A&M Project #: 1362-25
Re: 6 Forge Parkway
Industrial Building
Response to
Review Comments

Allen & Major (A&M) is in receipt of review comments from the BETA Group, Inc., dated March 20, 2024, for the above referenced project. Please find A&M's responses to these comments below. The initial comments are provided along with A&M's responses in **bold**.

Image 1 - View looking southwest, towards the development, from Route 140, Source: Google Maps

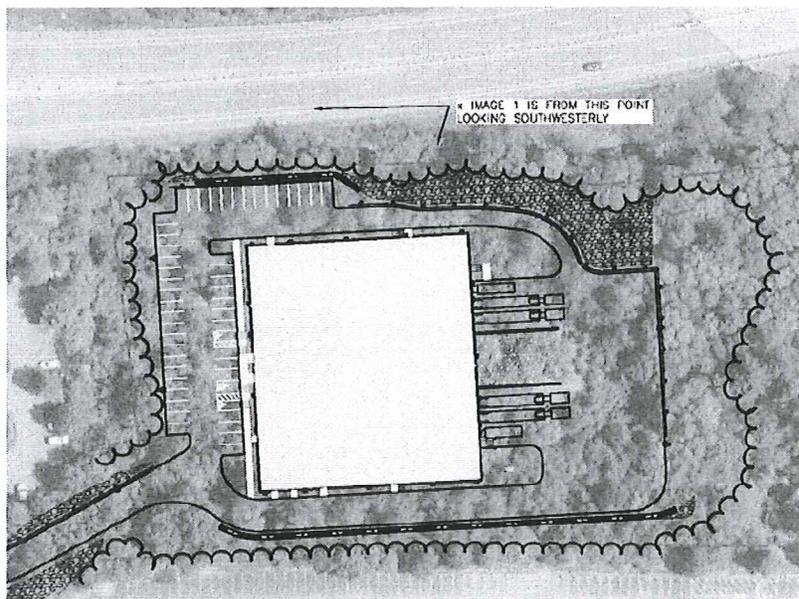
SP4. In accordance with §185-31, C(4)Review criteria. The Planning Board shall approve a site plan only upon its determination.....

(b) Reasonable use is made of building location, grading, and vegetation to reduce visibility of structures, parking area, outside storage, or other outdoor service areas (e.g., waste removal) from public views.

Based upon the 2021 Aerial imagery available it is difficult to determine if the vegetation along route 140 is sufficient to screen the loading docks from view from the roadway. In addition, because of the steep grades to the floor of the valley from the loading docks area will be covered in riprap without any vegetation. BETA recommends that the applicant provide additional information to the Board to allow that determination to be made.

A&M Response: Based on available aerial and street view imagery, it appears that a substantial vegetated berm exists and will separate and screen the development from Route 140. See Images 1 and 2 below.
